DOC:IEEE P802.11-98/20a

Proposed Modifications to
M-ary Bi-Orthogonal Waveform
Presented in
doc:IEEE P802.11-97/144

Raytheon Systems Company

Transmitter Incorporating the Suggestions Full-Data Rate

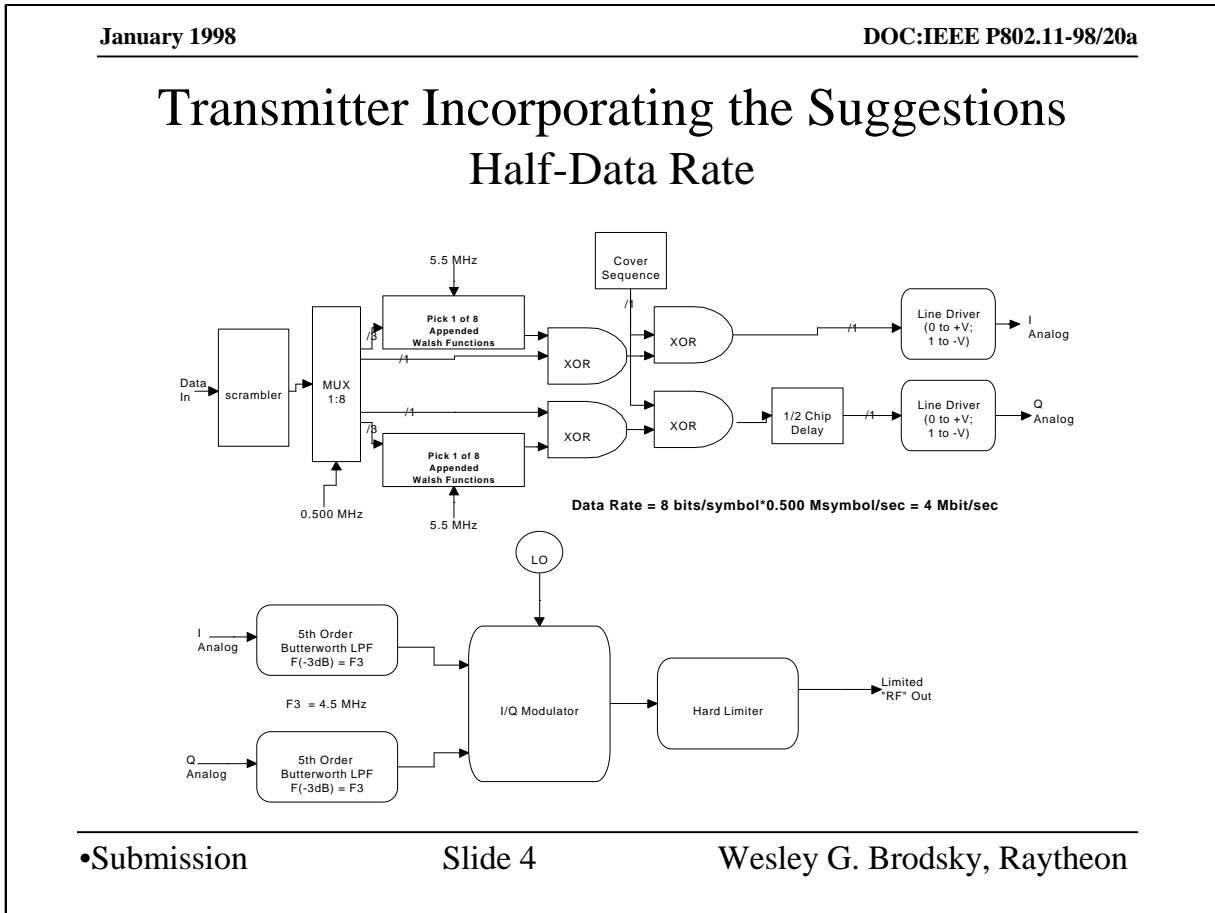
The waveform originally [1] proposed requires RF power amplifier backoff . We at Raytheon feel operation of the transmitter’s RF power amplifier at saturation is preferable for two reasons. First, dc power efficiency is improved. Second, it is not necessary to precisely control the gain throughout the transmitter RF chain in order to precisely control RF transmitter output power. Instead, only the saturated power output of the power amplifier need be controlled. It is well known [2] that Offset Quadrature Phase Shift Keying exhibits less spectral growth through a saturated power amplifier than Quadrature Phase Shift Keying. This principle can be applied to the proposed waveform by delaying the Q channel ½ a chip period more than the I channel. Since the waveform originally proposed already requires the receiver process the signal coherently, it can distinguish the I from the Q channel, and re-align them.

Effect of LPF BW on RF BW

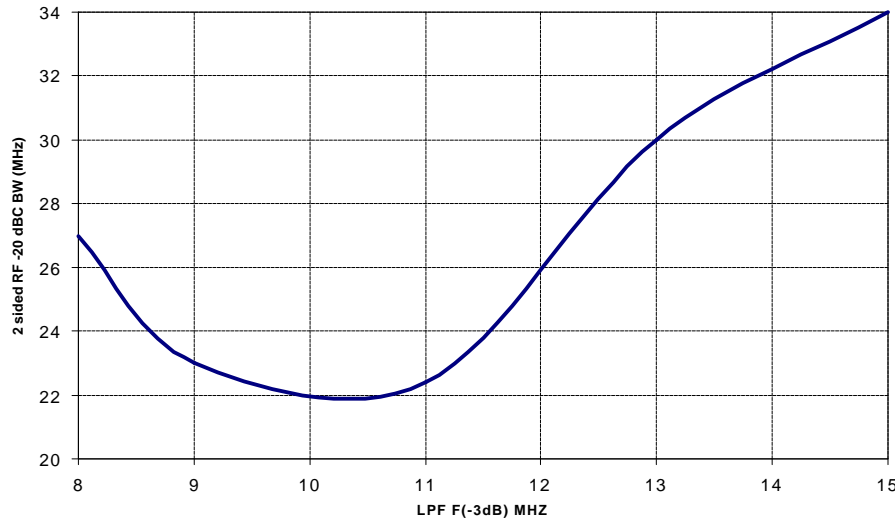
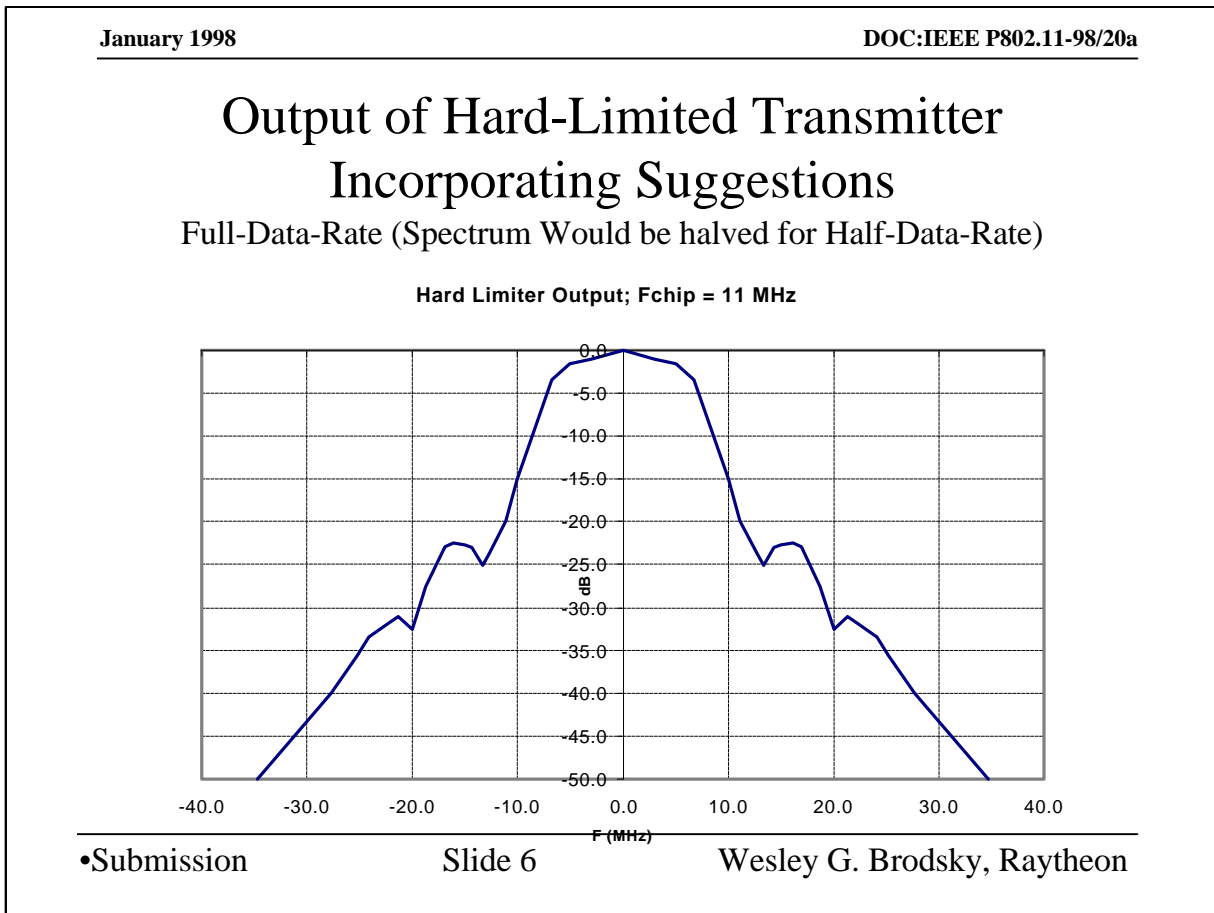
We ran a simulation to determine the performance of the waveform we propose. Both the I and Q baseband "rails" were filtered by a 5th order Butterworth Low Pass Filter of -3dB bandwidth F3. We determined the spectrum on the hard limiter output from the FFT of the RF waveform with random data applied to the modulator. The figure above shows how the bandwidth between the two points 20 dB below the peak of the signal varied as F3 was changed. We selected F3 = 9 MHz.

The spectrum that a spectrum analyzer would give in "peak hold" mode was estimated from the simulation output spectrum. From this, it is obvious that 3 or 4 channels would fit into the 83 MHz band, even though this is the output of a hard limiter. This spectrum does not meet the present IEEE802.11 spectral mask requirements for the 1 and 2 Mb/s Direct Sequence waveforms. However, there is no reason a new mask could not be used for the new waveform, as long as FCC requirements are met.

Output of Hard Limiting Transmitter for Waveform Proposed in IEEE P802.11-97/144 Full-Data-Rate Case

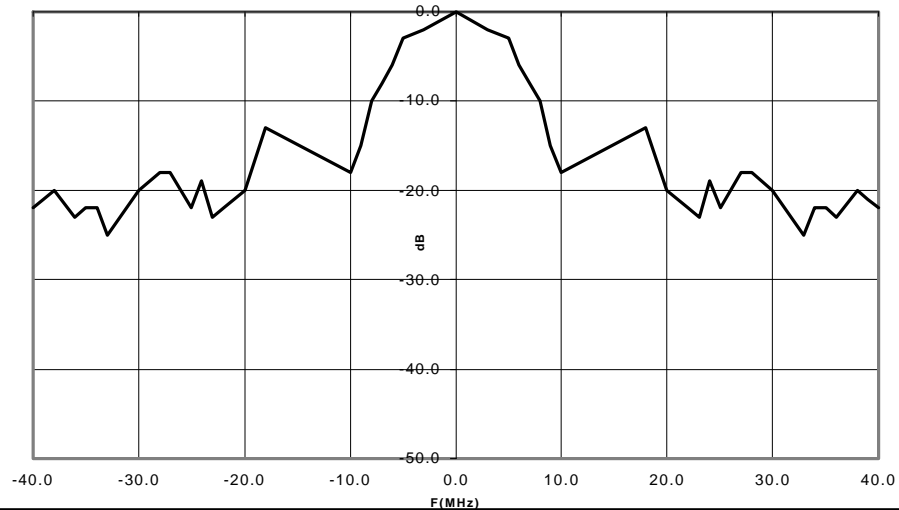
For the sake of comparison, the case of I and Q aligned in time was simulated. This is what was originally proposed. The same procedure to find the best bandwidth for the single I-channel 5th order Butterworth LPF was repeated. The best bandwidth was 5.5 MHz. The above figure shows the resulting spectrum, again at the hard limiter output. The bandwidth between the -20 dBc points is 60 MHz. Only one channel would fit in the allocated band.

Output of Hard Limiting Transmitter for Waveform Proposed in IEEE P802.11-97/144 Half-Data-Rate Case

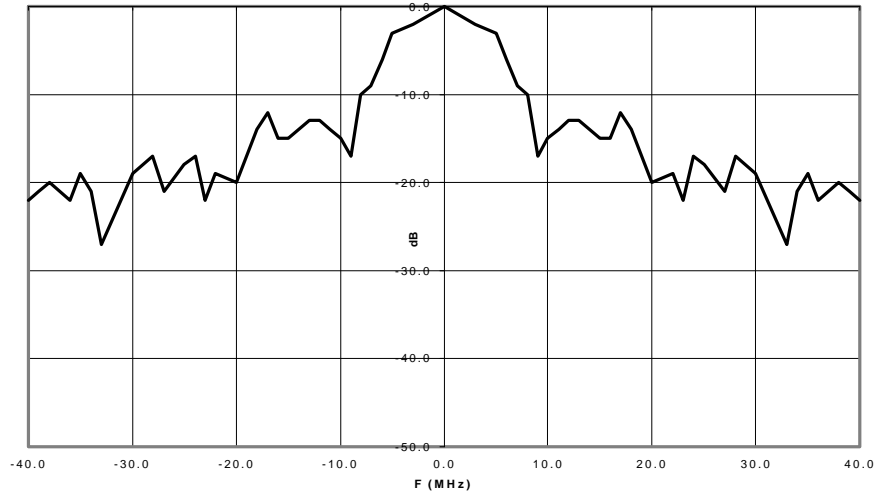
Originally binary, rather than quadrature, modulation was proposed for the half-data-rate case. Binary modulation exhibits more spectral growth through a saturated power amplifier than does offset quadrature modulation. This is because it goes through the origin of the I/Q plane, so has a high amplitude variation. We simulated this modulation. The same procedure to find the best bandwidth for the single I-channel 5th order Butterworth LPF was repeated. The best bandwidth was 5.5 MHz. The above figure shows the resulting spectrum, at the hard limiter output. The bandwidth between the two -20 dBc points is approximately 60 MHz. (Even though the data rate was halved, this method still uses a chipping rate of 11 MHz.) Only one channel would fit in the allocated band.
